Product Discontinuation Notices

No.2010200E

Discontinuation Notice of Portable Multi Loggers ZR-RX20 and ZR-RX40series

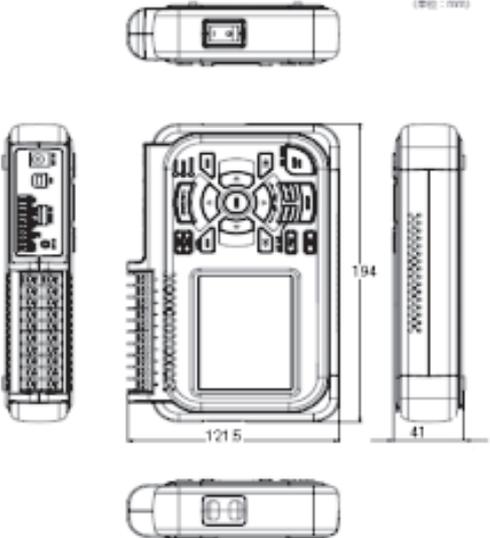
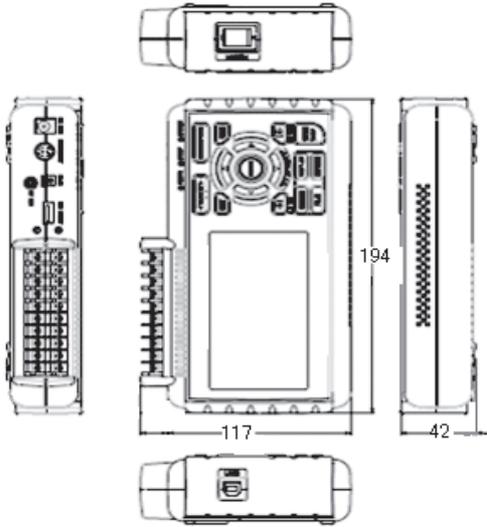
Product discontinuation	Recommendable replacement
<p>ZR-RX20 series L: 194 D: 121.5 H: 41 [mm]</p>  <p>Mounting : none</p>	<p>ZR-RX25 series L: 194 D: 117 H: 42 [mm]</p>  <p>Mounting : 2-M4</p>

Product discontinuation	Recommendable replacement
<p>ZR-RX40 series L:232 D:152 H:50 [mm]</p>  <p>Mounting : 2-M4</p>	<p>ZR-RX45 series L:232 D:152 H:50 [mm]</p>  <p>Mounting : 2-M4</p>

Body Color

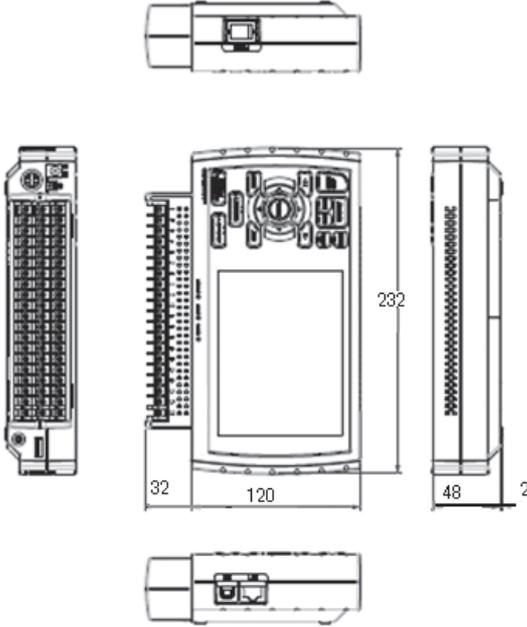
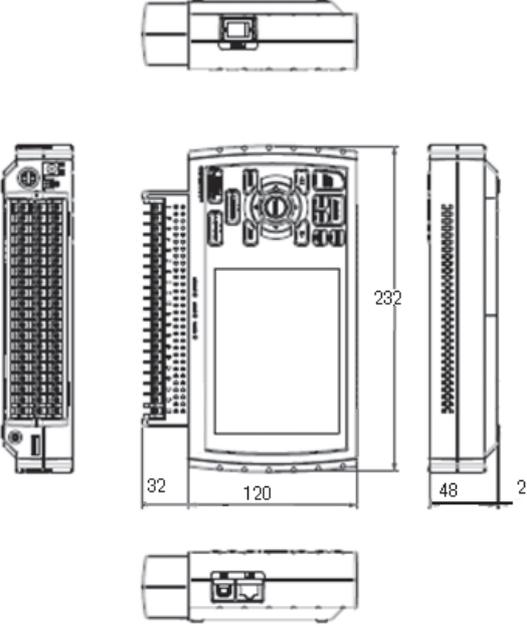
Product discontinuation	Recommendable replacement
<p>ZR-RX20 series Color : Silver</p> 	<p>ZR-RX25 series Color : Black</p> 
<p>ZR-RX40 series Color : Silver</p> 	<p>ZR-RX45 series Color : Black</p>
